SHEARON HARRIS NUCLEAR POWER PLANT
SUCCESS PATH LOGIC DIAGRAM AND
SUPPORTING INFORMATION DEVELOPMENT
RSC 94-01
REVISION 1 AND ADDENDUM 1

Shearon Harris Nuclear Power Plant Success Path Logic Diagram and Supporting Information Development

Shearon Harris Nuclear Power Plant Success Path Logic Diagram and Supporting Information Development

Figure AD-1. Simplified Illustration of the Auxiliary Feedwater System Discharge Piping (Reproduced from Reference 3)

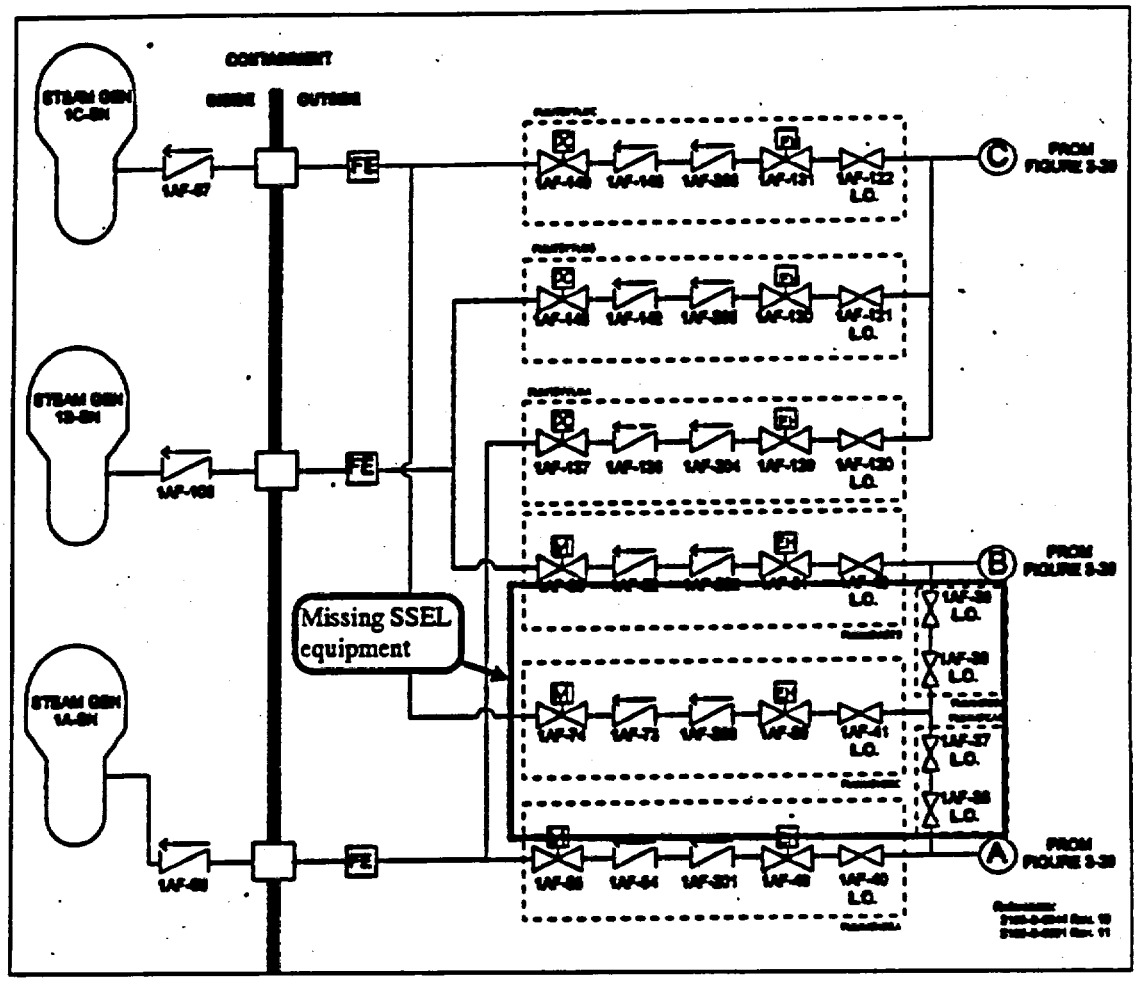
Peer review comment #18 states:

> A path for feeding the "C" steam generator from either of the motor driven auxiliary feedwater pumps appears to have been excluded from the shutdown path. Is there any reason for this?

An examination of the safe shutdown equipment listing (Appendix B, page B-1 through B-3, Reference 1), identified that this path was inadvertently omitted. The path, shown in Figure AD-1, provides auxiliary feedwater to the steam generators from either auxiliary feedwater motor-driven pump.

The inclusion of this path requires the addition of the following components to the equipment list that will require examination:
